**FARRAGUT VISUAL RESOURCES REVIEW BOARD
AGENDA**

MEMORANDUM

TO: Farragut Visual Resources Review Board
FROM: Bart Hose, Assist. Community Development Director.
SUBJECT: Regularly Scheduled Meeting - Tuesday, September 28, 2021, at 7:00 p.m.

SIGN B

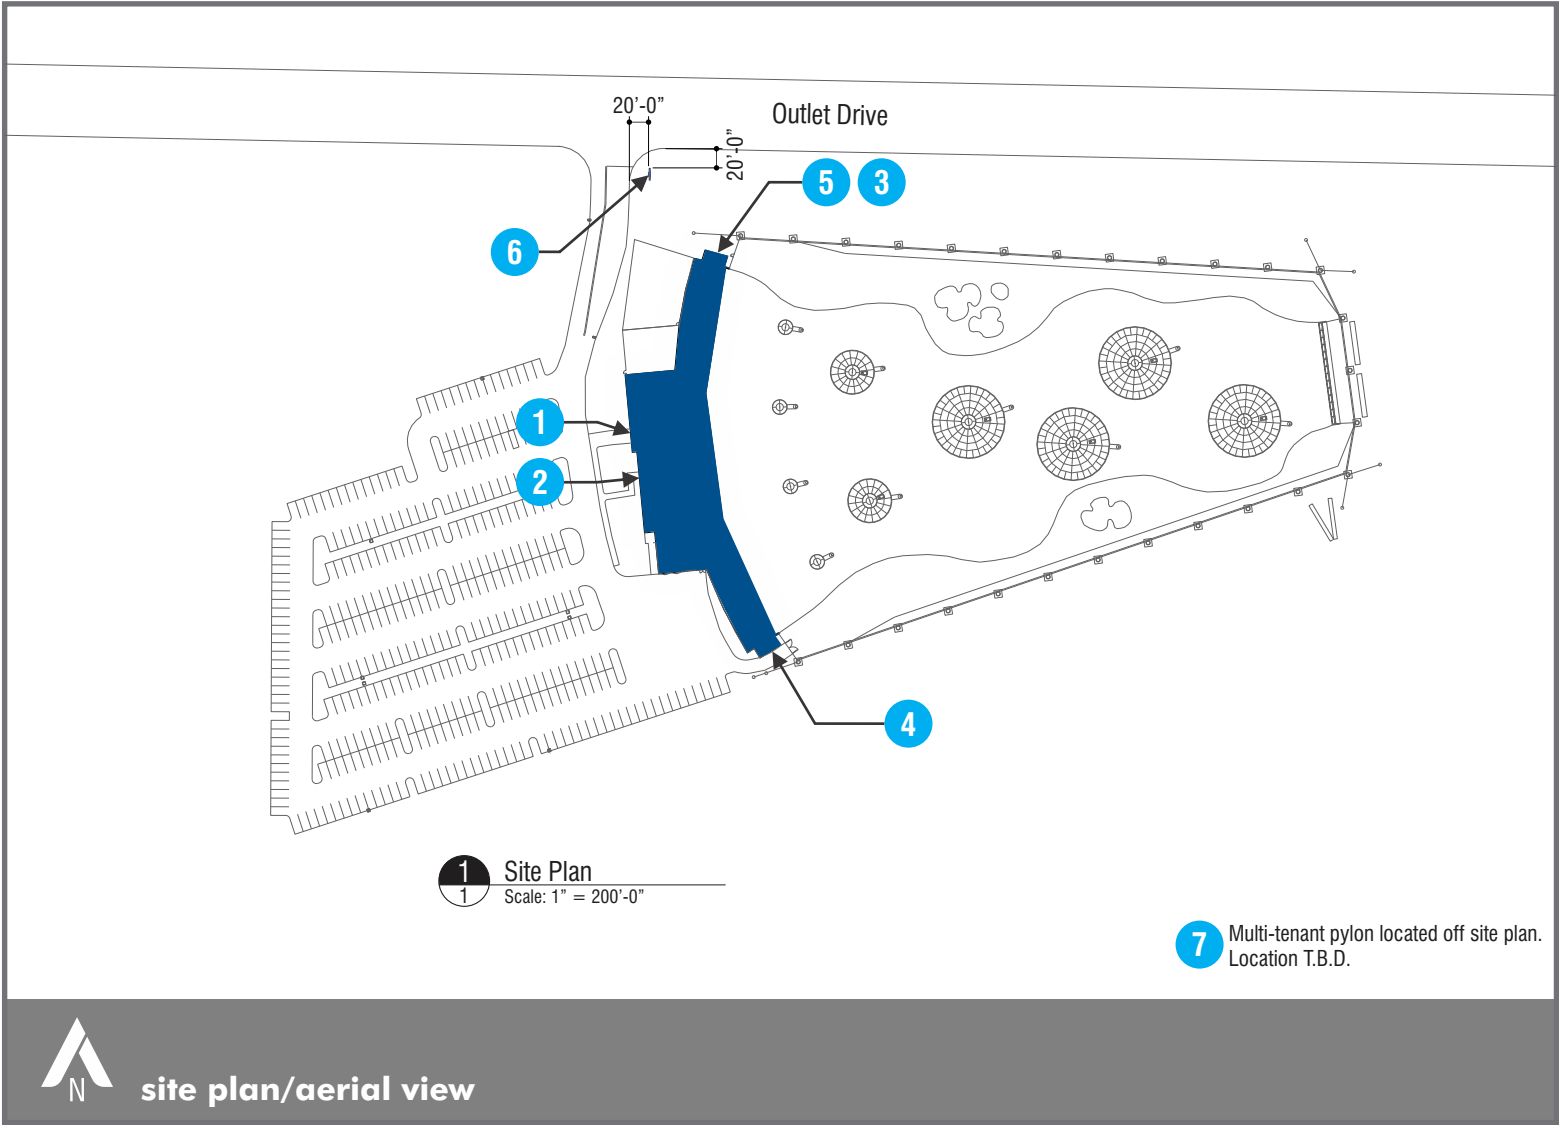
The plan includes a new 40 square foot monument ground sign. The new sign will replace the existing ground sign and the applicant plans to mount it on the existing sign base on the site. Unfortunately, the submitted plans did not include all of the information needed to fully document code compliance. The applicant is currently working on the needed revisions. The correct property address also needs to be used on the sign. According to Knox County, the official address for this property should be 639 North Campbell Station Road. In addition, and as noted for the proceeding agenda item, the new ground sign is part of a larger site renovation project that was begun without adequate application, review, and approval. Again, no permits will be issued until the Town has received adequate plans for all of the proposed site renovations and those renovations have been reviewed and approved.

Given the nature of proposed sign replacement, it should be relatively easy to document compliance with the Town's standards. The staff will make a full recommendation, based on any submitted plan revisions, at the meeting.

1 West Elevation
Scale: 1/32"=1'-0"

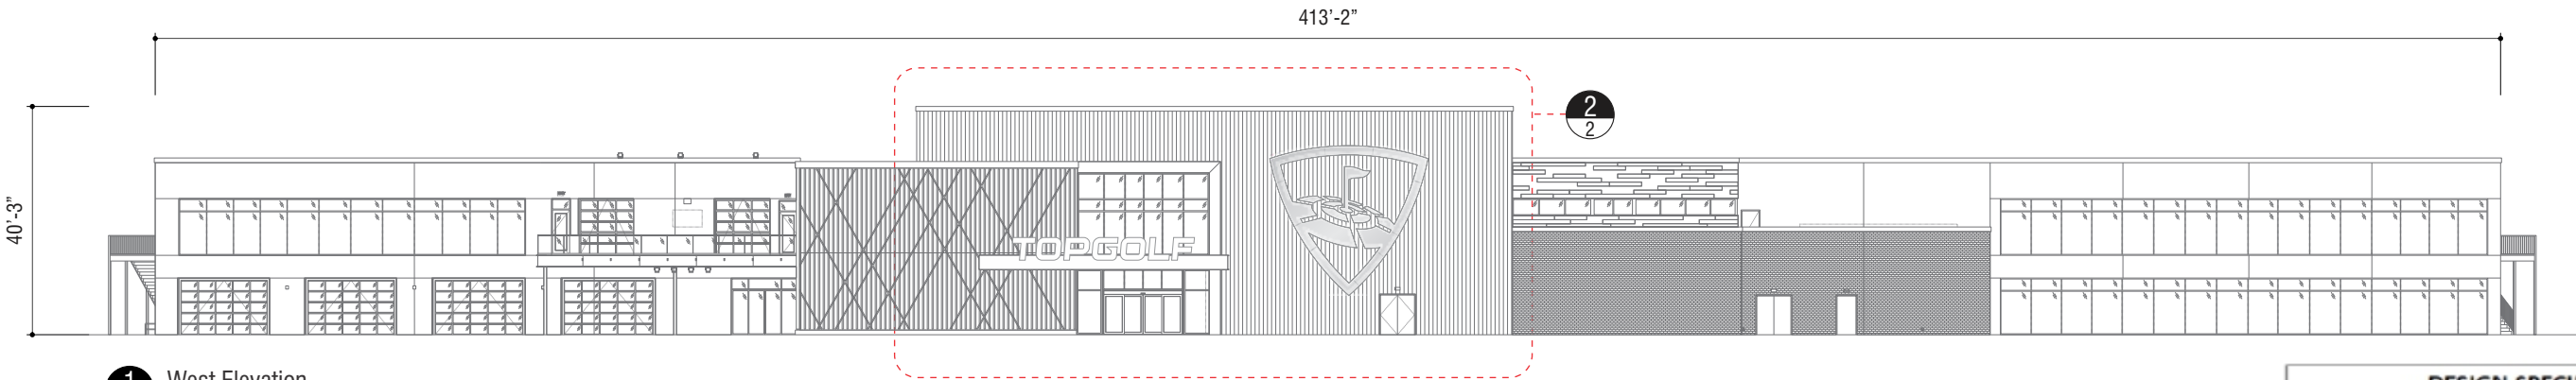
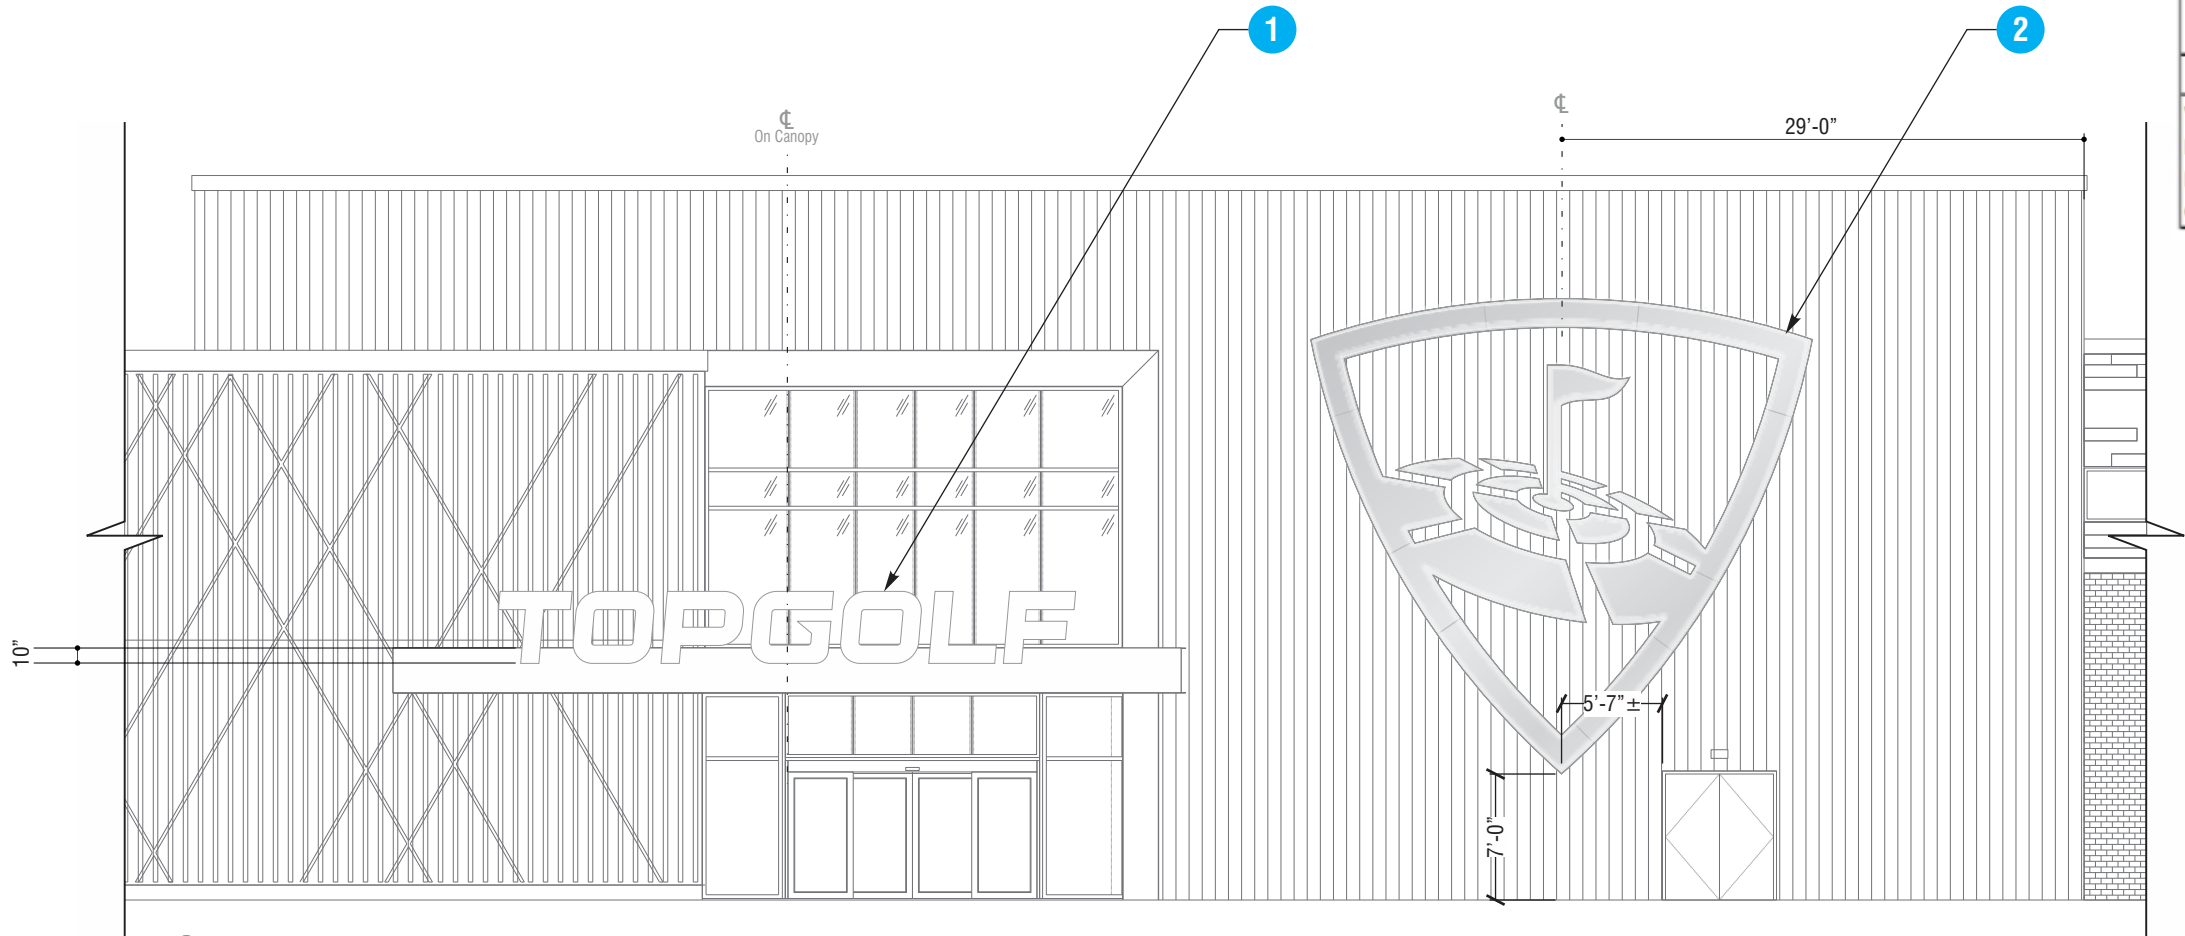
This item involves a request by Topgolf for an ordinance amendment to allow for a canopy mounted sign. Currently, the Sign Ordinance does not permit canopy signs and the Outlet Drive Regional Entertainment and Employment (OD-RE/E) Zoning District does not include any modifications to address the issue. The building proposed for the Topgolf site along Outlet Drive includes a structural canopy overhanging the main entrance. The company's standard design for this style of building includes a channel letter sign attached to the front of the canopy. Currently, the Town's sign ordinance permits wall signs, and it defines such as "*a sign attached parallel to and projecting not more than 12 inches from the wall of a building and does not project in part or in whole above the top edge of a building wall*". The proposed Topgolf sign would not meet the Town's definition of a wall sign and cannot currently be permitted without an amendment to either the Sign or Zoning Ordinance.
